**20-COA-0073**  
**1279 Bassett Avenue**

**Cherokee Triangle Architectural Review Committee**  
**Public Hearing**

**Kat Groskreutz, Historic Preservation Specialist**  
**June 10, 2020**

# Request

# Case Summary / Background

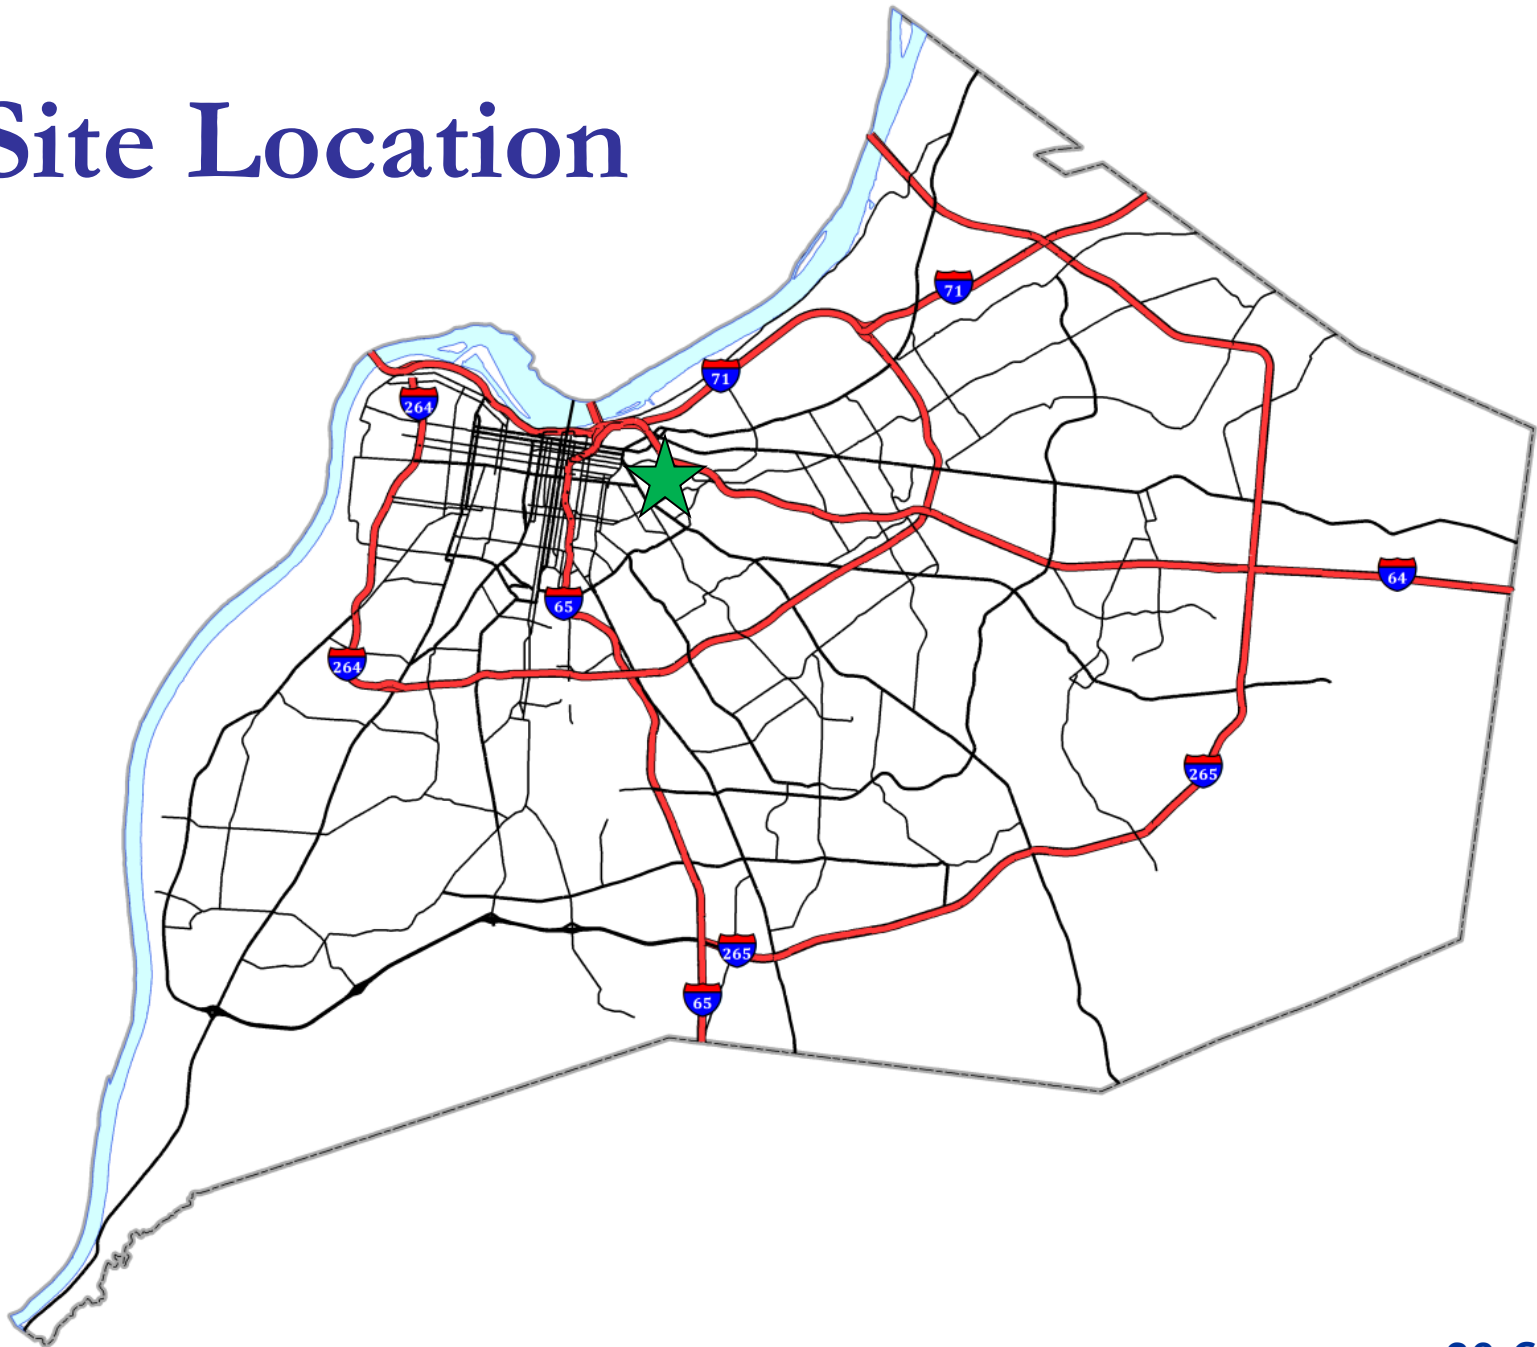
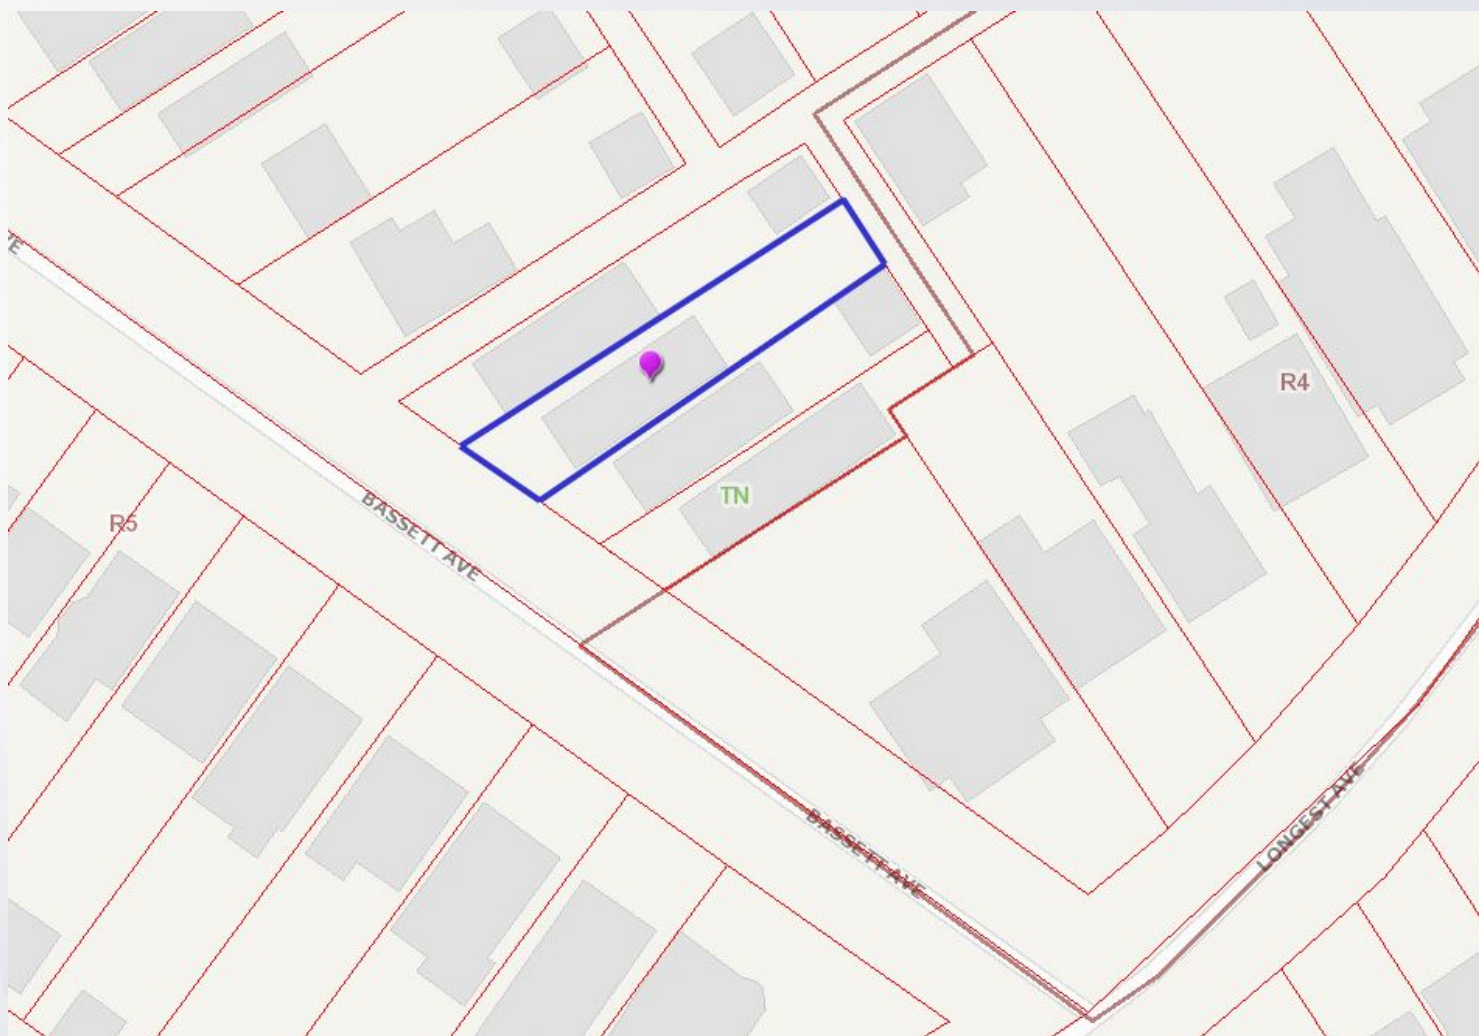
- Due to Covid19 restrictions, staff was unable to conduct an in-home site visit to assess the condition of the windows.
- They are boarded from the outside, so staff would not have been able to see the frames during an exterior only visit.
- The applicant provided multiple photographs to help staff review the request.
- The existing windows are a mix of wooden hoppers and wire mesh.

1. The glass block windows shall fit the historic window openings. No part of an opening shall be blocked-in to accommodate stock windows.
2. If the design or material changes, the applicant shall contact staff for review and approval.
